## Product Change Notice (PCN)

PCN Number: PCN-0451184R-01

Product(s) Affected: PJ-050A

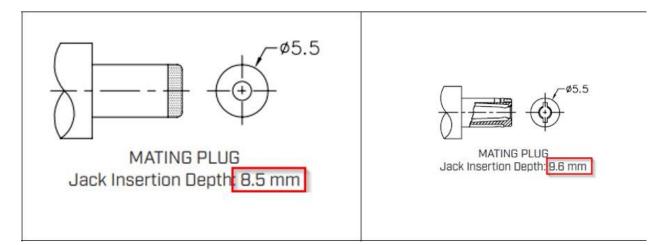
Description of Change: Mechanical, electrical, and material changes as shown below:

DESCRIPTION	MATERIAL	PLATING/COLOR
	MATERIAL	PLATING	center pin	copper alloy(H65)	nickel
pin	copper	nickel	terminal 1	C2680 t=0.35 mm	nickel-silver
11	brass	tin	terminal 2	C5210 t=0.25 mm	nickel-silver
al 2	copper alloy	tin	terminal 3	C2680 t=0.30 mm	nickel-silver
3	brass	tin	housing	PA9T (UL94V-0)	black
	PBT		cover	PA9T (UL94V-0)	black
